FORD E40D "UPDATE HANDBOOK"

INTRODUCTION FORD E4OD "UPDATE HANDBOOK"

**FORD E40D
VALVE BODY, SPACER PLATE, SPACER PLATE GASKETS,
CHECKBALL LOCATIONS, AND CASE CHANGES,
FOR THE 1996 MODEL YEAR**

Figure 6

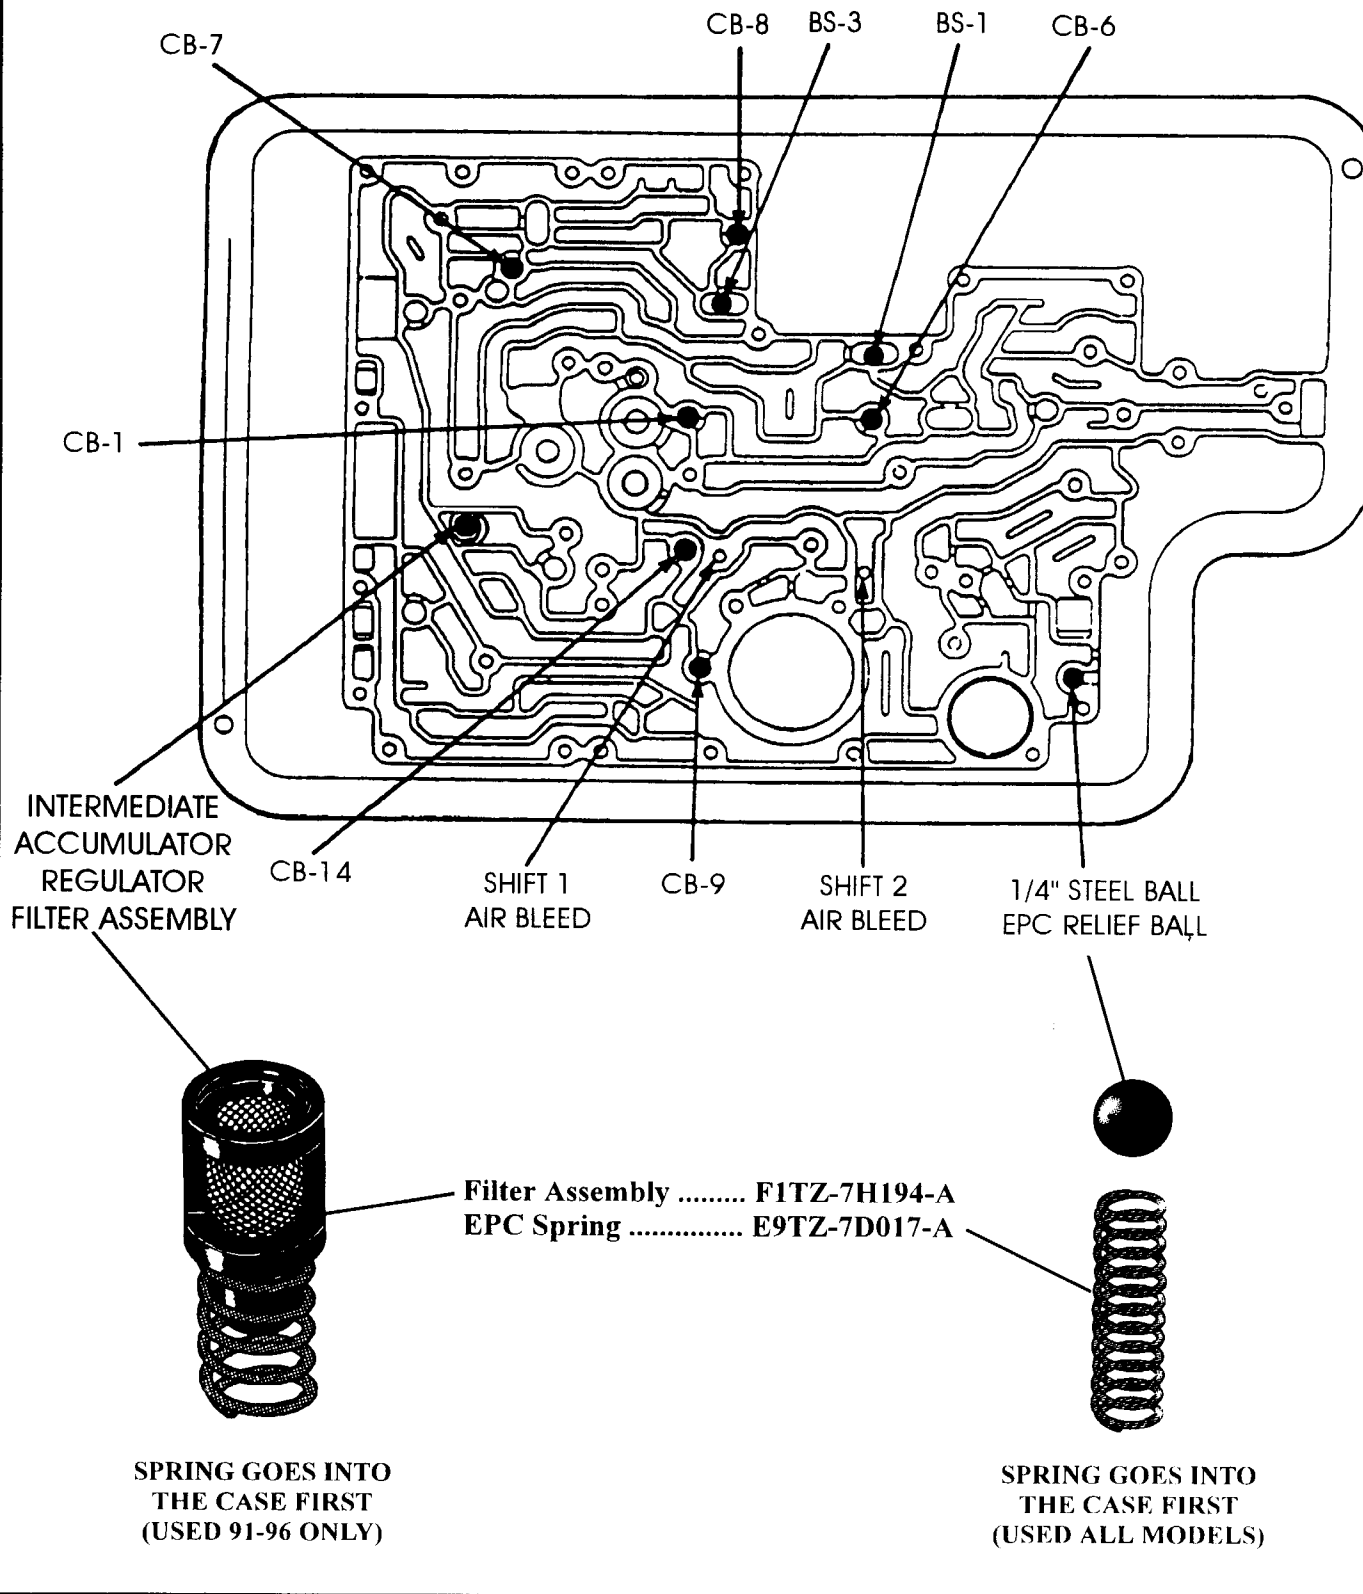
All 1996-UP Models - Requires **Eight** 5/16" rubber checkballs in the case, in the locations shown in Figure 6, and uses a 1/4" steel ball for the EPC blow-off, and the location is shown in Figure 6.

Figure 9

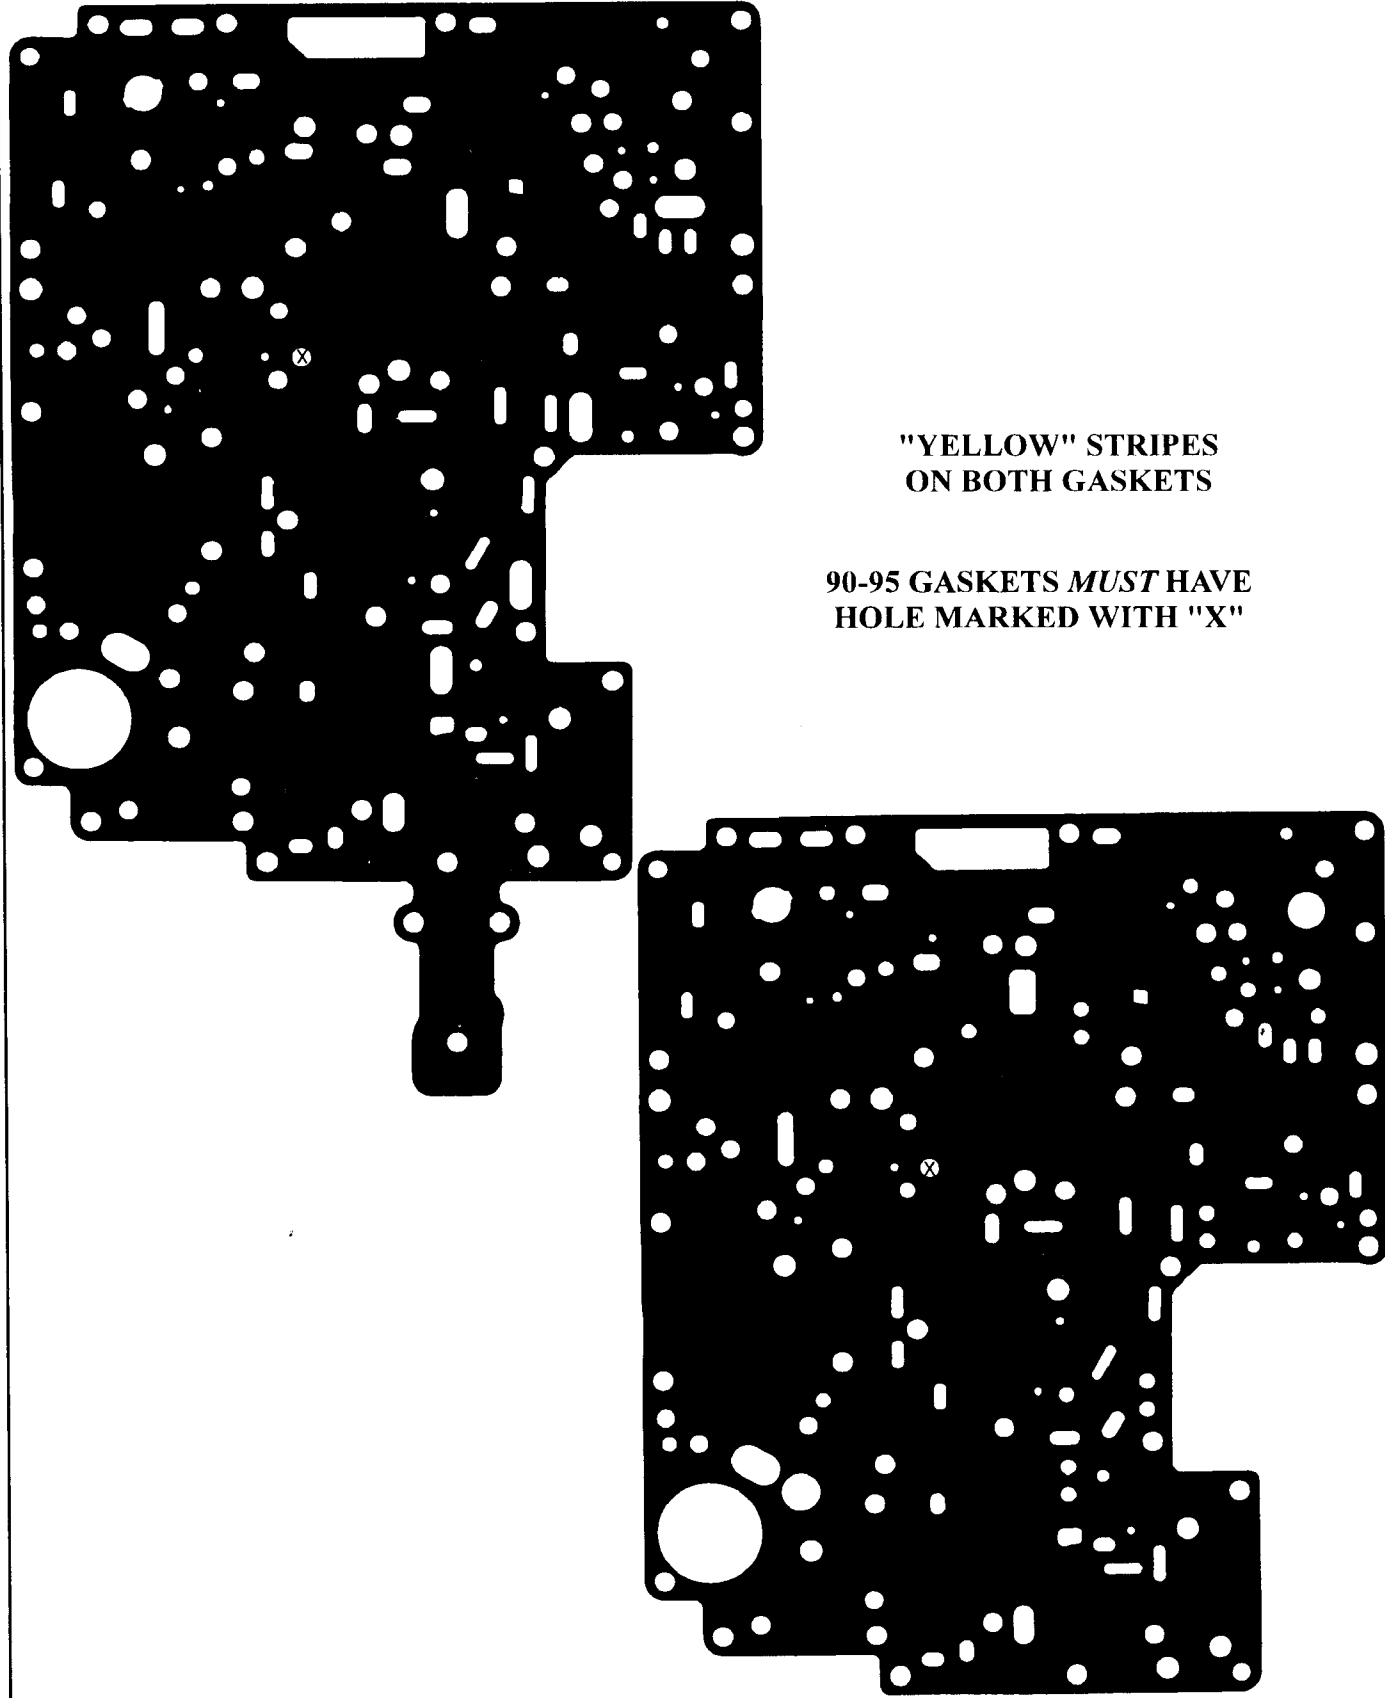
90-95 Models Only - Require the Spacer Plate Gaskets with solenoid feed hole (Marked X) in the location shown in Figure 9, and both gaskets have **Yellow I.D.** stripes

Figure 10

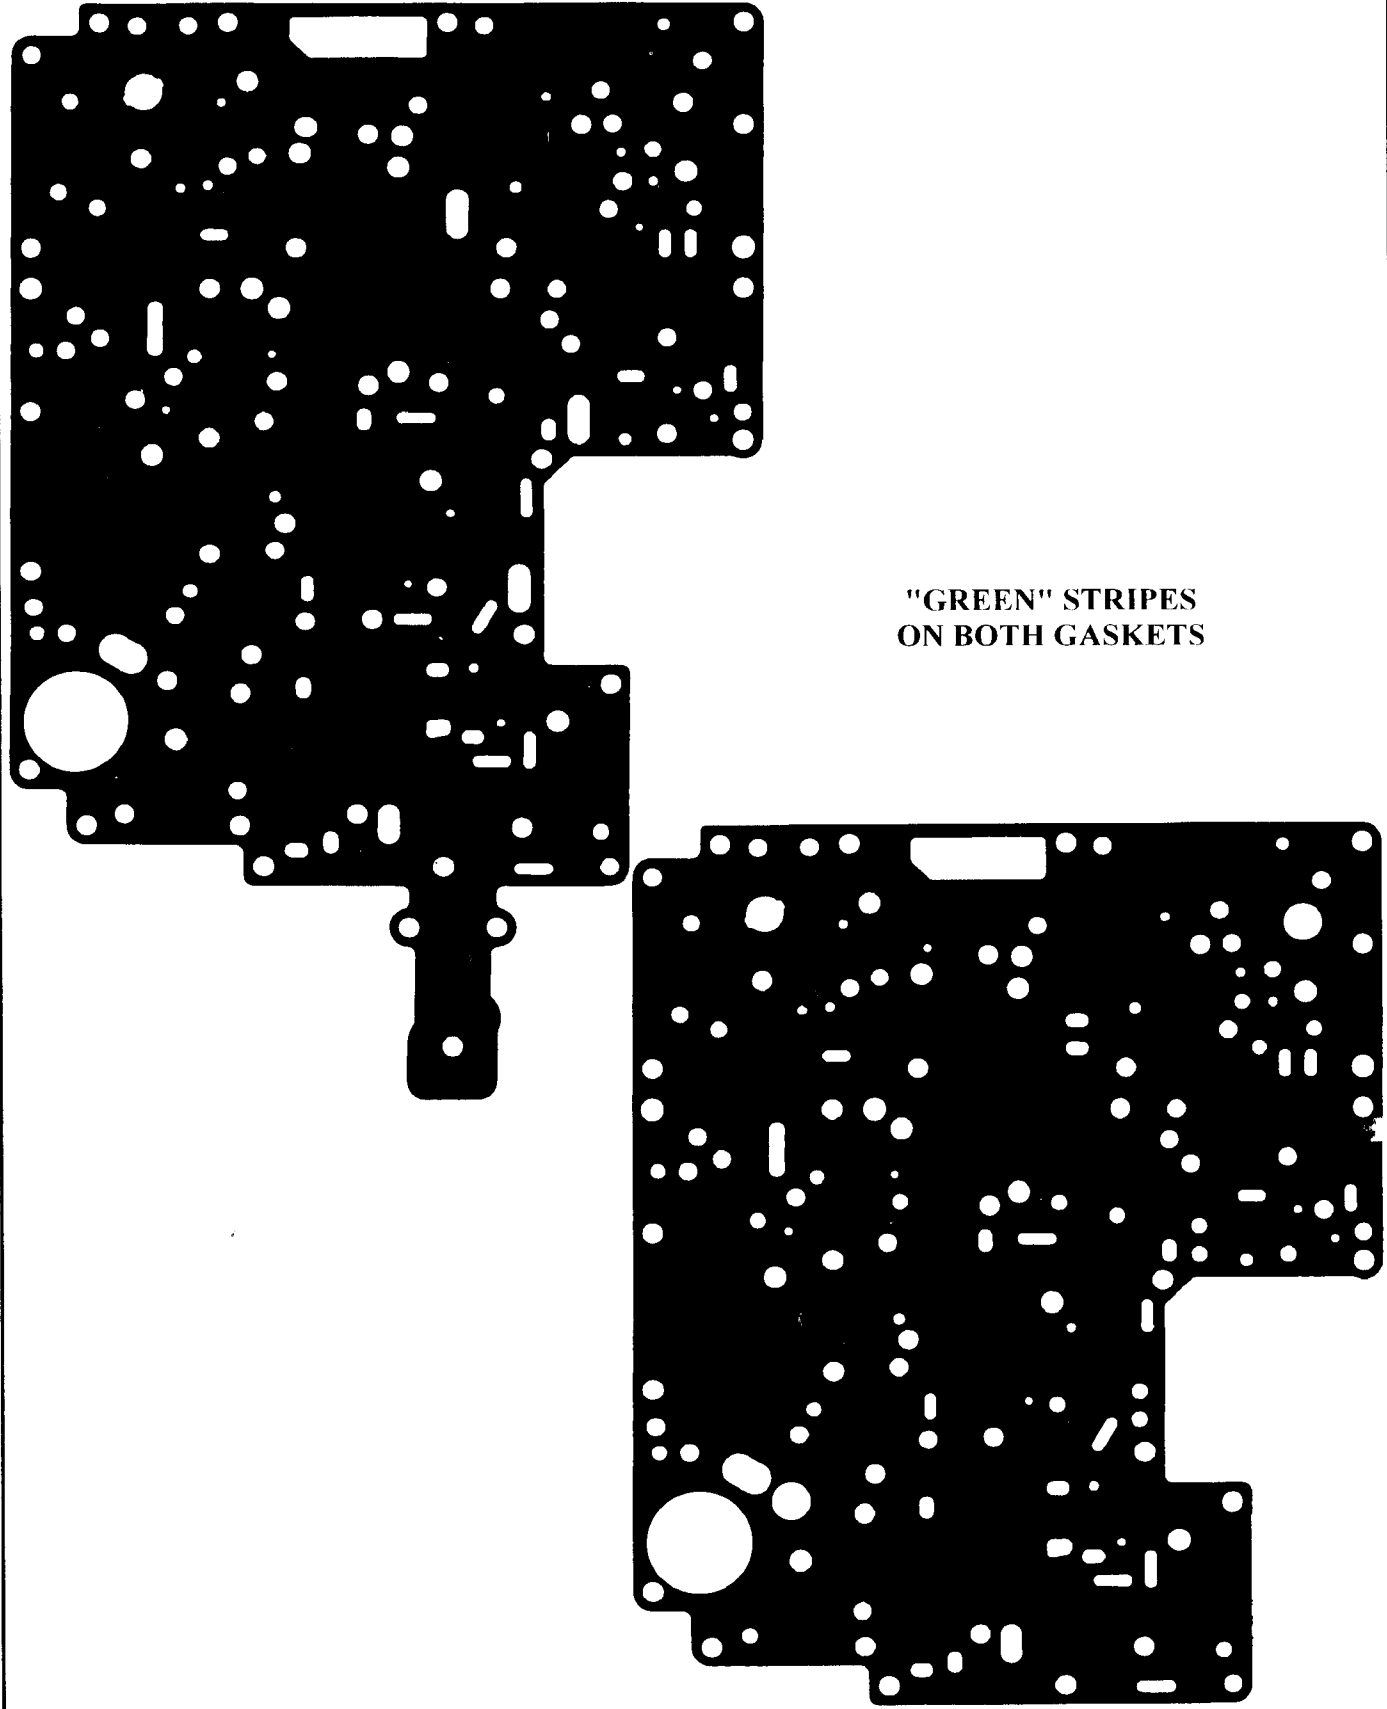
96-UP Models Only - Require the Spacer Plate Gaskets with **Green I.D.** stripes on both gaskets. These gaskets have a multitude of hole location differences, as shown in Figure 10.

Figure 11

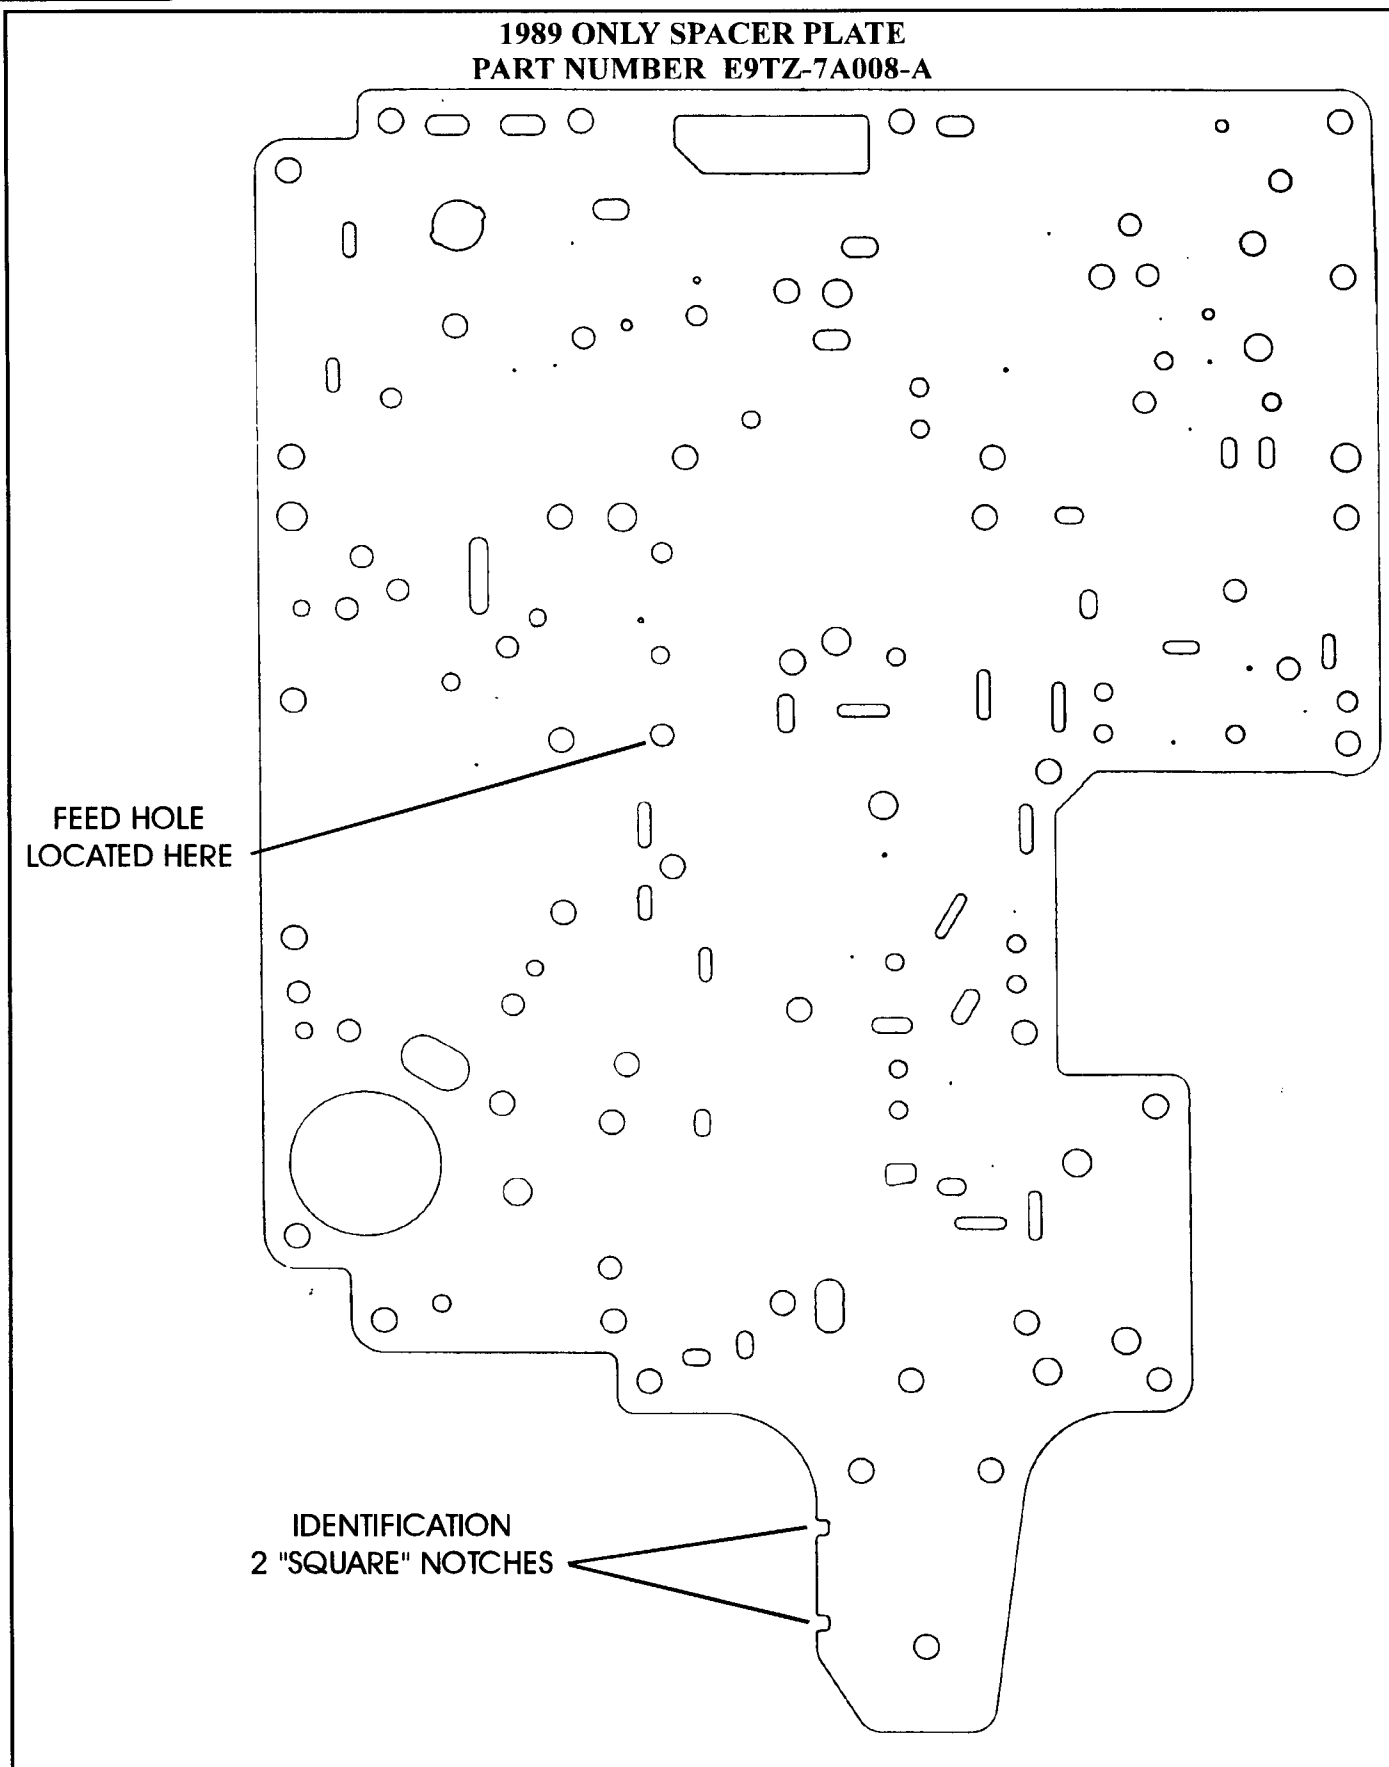
- (4) **MAIN VALVE BODY SPACER PLATE**- Has changed twice since the introduction in 1989.
1989 Models Only - Requires the Spacer Plate with the solenoid feed hole in the location shown in Figure 11, and has two "Square" notches for identification

Figure 12

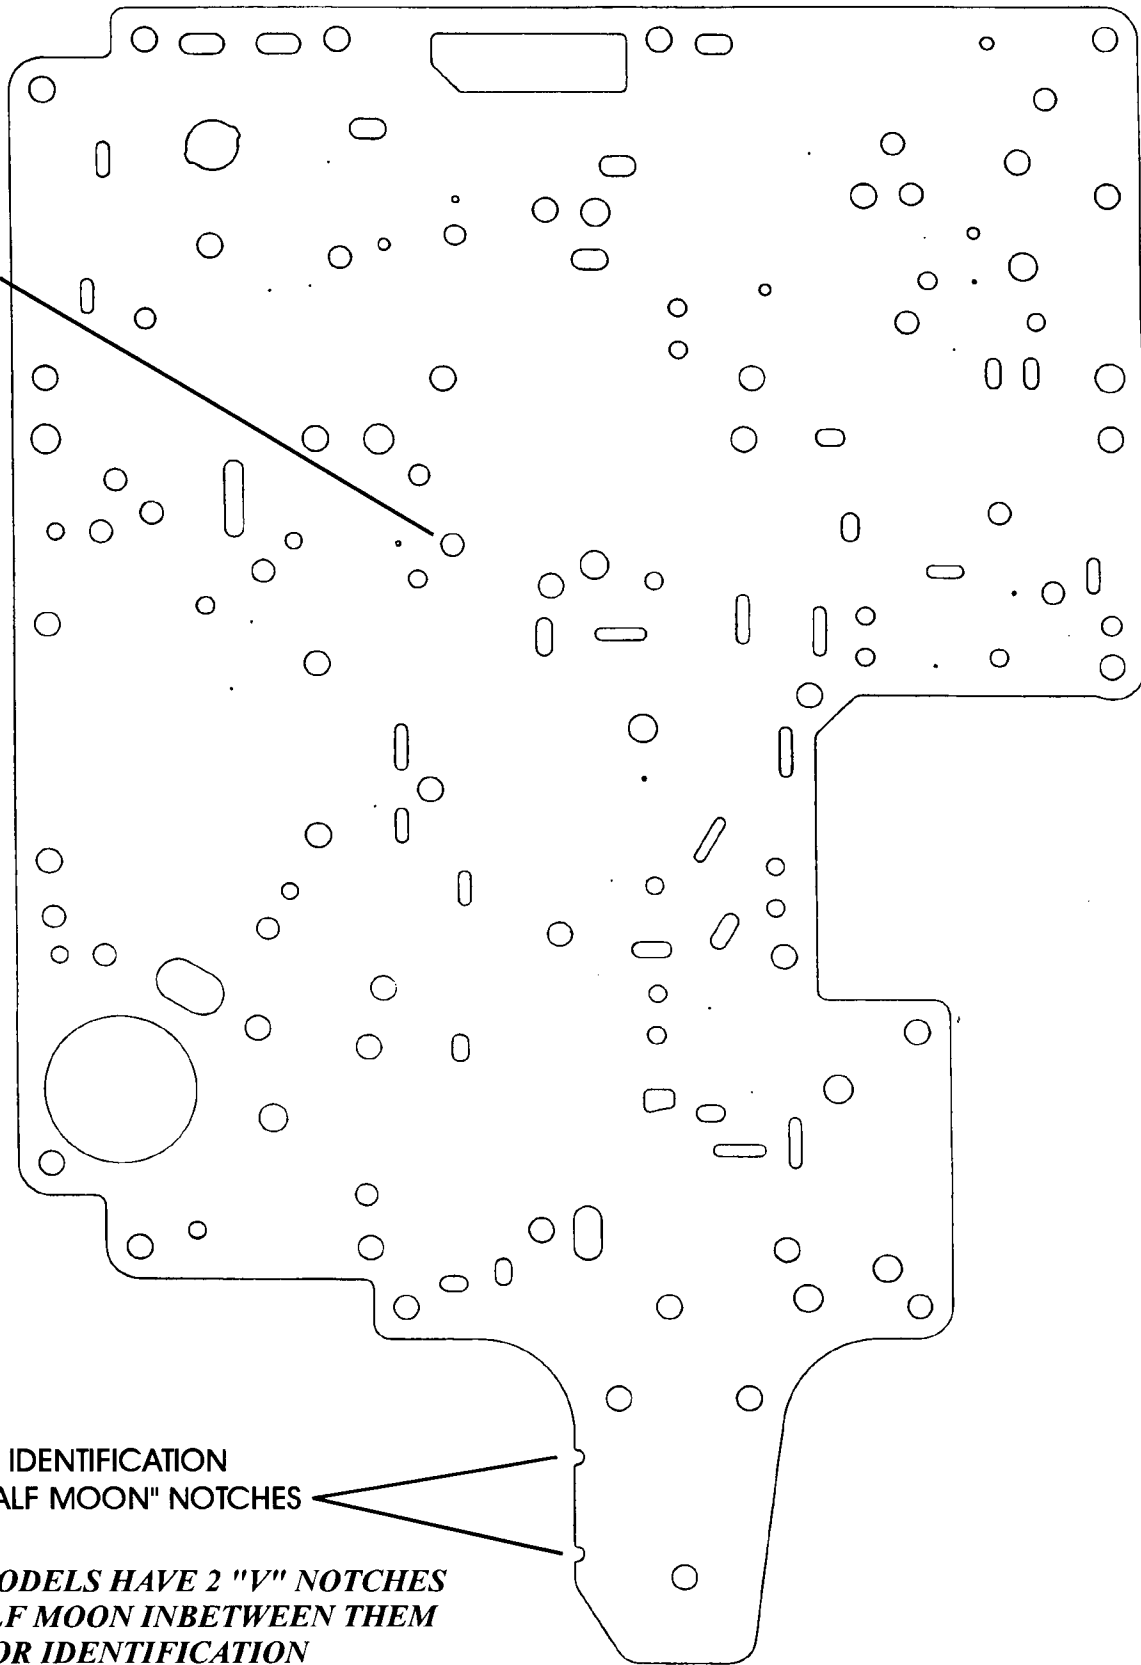
90-95 Models Only - Requires the Spacer Plate with the solenoid feed hole in the location shown in Figure 12, and has two "Half Moon" notches for identification. Note; Some models have two "V" notches with one "Half Moon" notch between them for identification.
